- Attn: Ms. Katherine Landman Navy Technical Representative Code 18232
- Re: Contract N62470-89-D-4814 Navy CLEAN, District III Contract Task Order (CTO) 0232 Supplemental Groundwater Investigation/Feasibility Study (SGI/FS) Operable Unit (OU) No. 10, Site 35 MCB, Camp Lejeune, North Carolina

This letter presents amendments to the Remedial Investigation/Feasibility Study (RI/FS) Work Plan and Sampling and Analysis Plan (SAP) for Operable Unit (OU) No. 10 (Site 35) Camp Geiger Area Fuel Farm. These amendments were necessary to support the additional work to be conducted under the Supplemental Groundwater Investigation (SGI) at OU No. 10. The majority of information provided in the original Final Work Plan and SAP (Baker, 1993) is still applicable to the work scheduled to occur under the SGI. Specific sections of the original Work Plan and SAP have been modified to accommodate changes to the project's tasks, schedule, and project team. The health and safety concerns addressed in the Final RI/FS Health and Safety Plan (HASP) (Baker, 1993) are applicable to the SGI. As such, no modifications to this document were necessary for it to be followed during SGI field investigation activitie

FIGURE 3 PROPOSED SCHEDULE FOR SGI FIELD WORK SITE 35 (OPERABLE UNIT 10), MCB, CAMP LEJEUNE

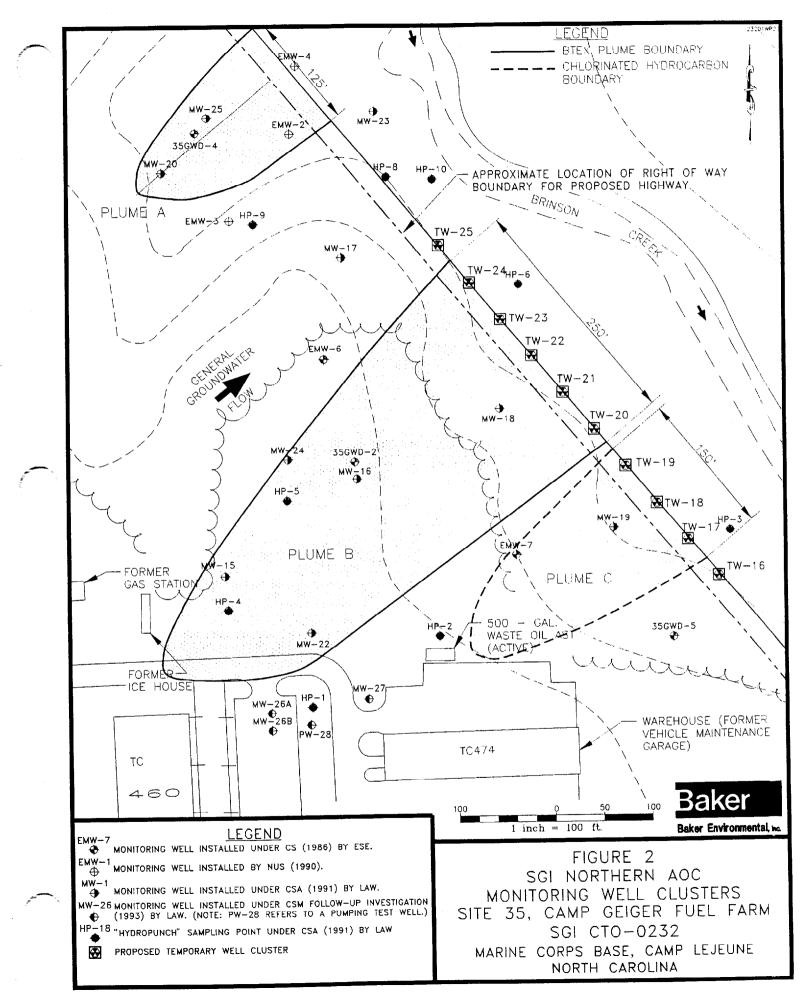
Figure 3 depicts the proposed schedule for SGI field work and Figure 4 is a revised schedule for all proposed RI/FS and SGI activities at Site 35. It is anticipated that field activities will commence the week of April 8, 1996 and to proceed through May 15, 1996. A summary of project deliverables is provided in Table 7.
